Access Compliance Report

Public Rights-of-Way

(Pedestrian Signals)

Intersection ID: N/A	Main Street:	Cross Street: N/A	Location: N/A
ADA ID: 3A602E9ADB05	Signal Type: One Push Button-APS	Overall Compliance: No	Severity Score: BTN 1: N/A BTN 2: N/A No BTN: N/A
Codes/Mitigation Info/Possible Solution		Field Measurements/Component Compliance

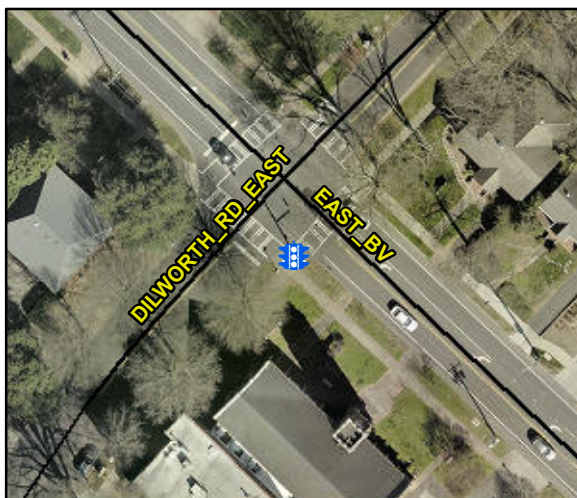
Surveyor Notes: THERE IS A VOICE, BUT
VOL REALLY LOW

PROW/ADA: R209.1, MUTCD 4e.10

Possible Solutions: Remove & Replace
Replace APS Button With New APS Button.
